Order No. EA-12-049

Quad Cities Nuclear Power Station, Units 1 and 2
Renewed Facility Operating License Nos. DPR-29 and DPR-30
NRC Docket Nos. 50-254 and 50-265

Subject: Second Six-Month Status Report in Response to March 12, 2012 Commission Order Modifying Licenses with Regard to Requirements for Mitigation Strategies for Beyond-Design-Basis External Events (Order Number EA-12-049)

Quad Cities Nuclear Power Station, Units 1 and 2 Second Six Month Status Report for the Implementation of Order EA-12-049, Order Modifying Licenses with Regard to Requirements for Mitigation Strategies for Beyond-Design-Basis External Events

OIP Attachment 3 - Revised Conceptual Sketch

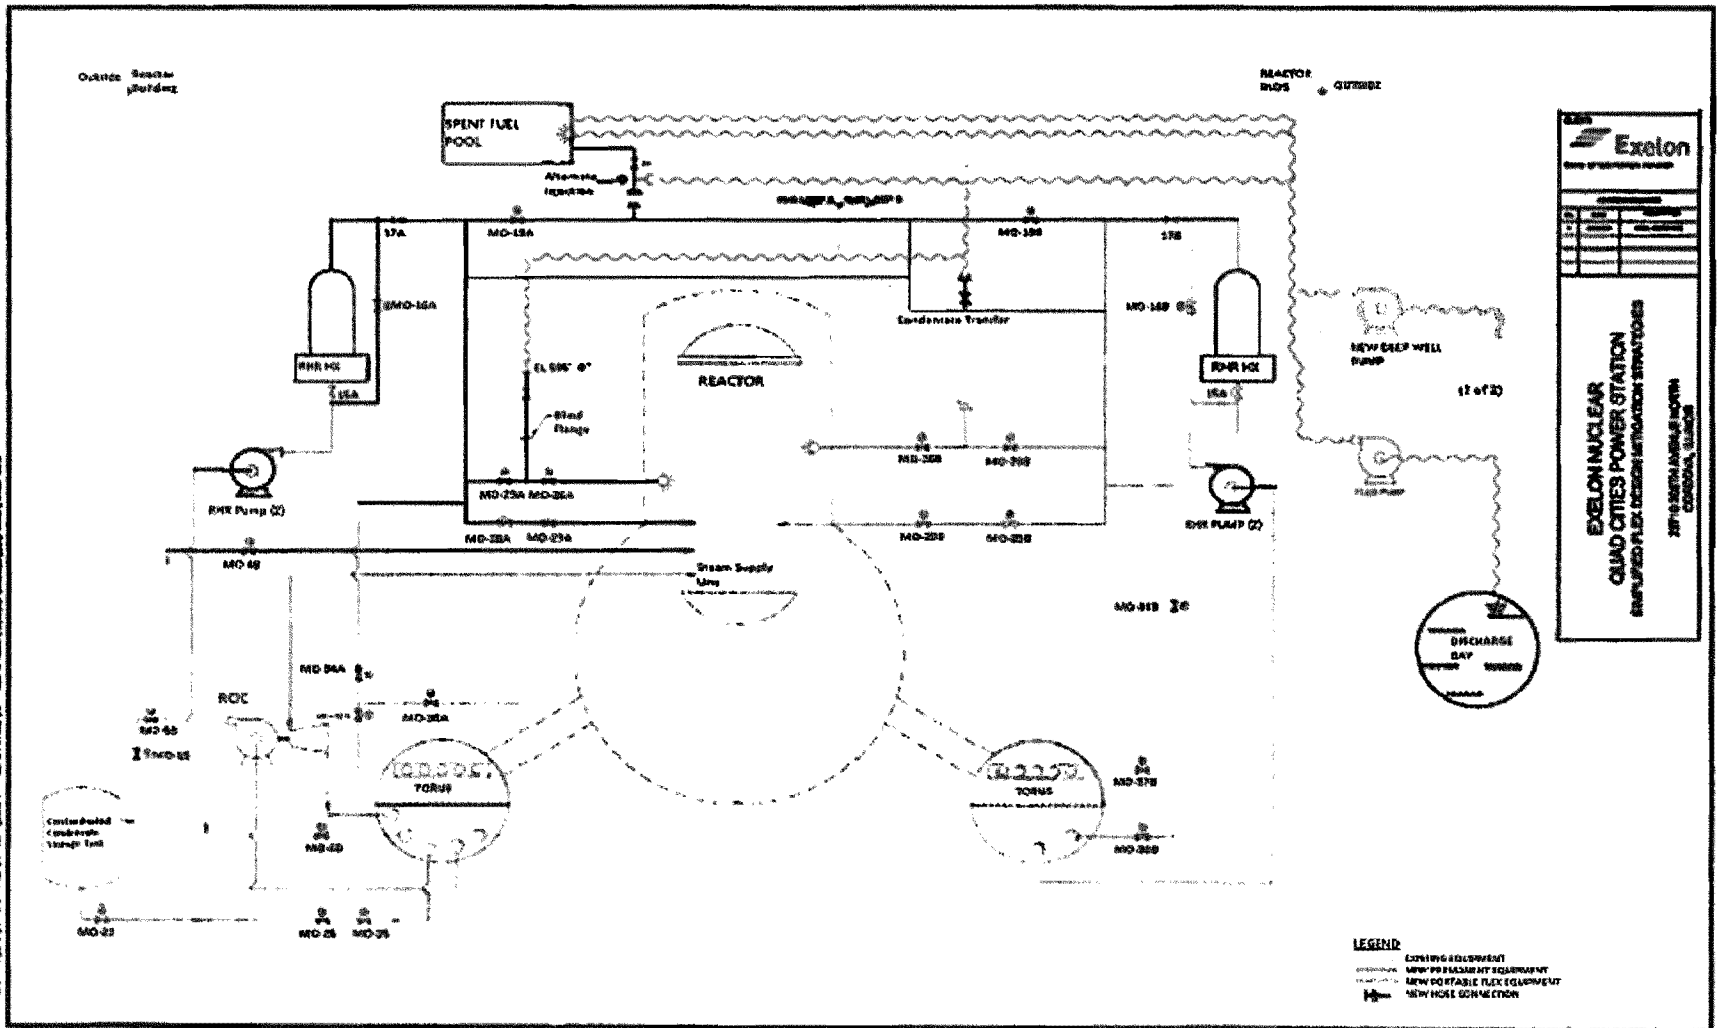
(OIP page 15) The second Storz connection design has changed from the OIP, pages 15, 25, 17 and 26. The second Storz connection location is to be installed on each unit's condensate transfer system piping, which is normally used to refill the RHR system following system piping draining for maintenance. Located on the ground floor (595') reactor building on the central wall between Units 1 and 2, the piping provides multiple fill points to both loops of the RHR system. Functioning like the original, this connection will allow supplying water to both the RPV and the Suppression Chamber. Hose routing to this connection point will not require use of the stairwell to access second floor (623') of the reactor building. This connection will no longer be located above the maximum flood level (change to Flooding section on pages 18, 27, 36 and 44); however, the Quad Cities river flood strategy does not solely rely on use of this connection and necessary connections will be made prior to reaching the maximum flood level. This connection is located in the Reactor Building. (See revised Attachment 3, Conceptual sketch.)

(OIP page 25) Suppression Pool Makeup: Suppression Pool makeup can also be supplied by the FLEX deep well pumps similar to the RPV makeup, via the existing A RHR loop connection or new Condensate Transfer to RHR system connection.
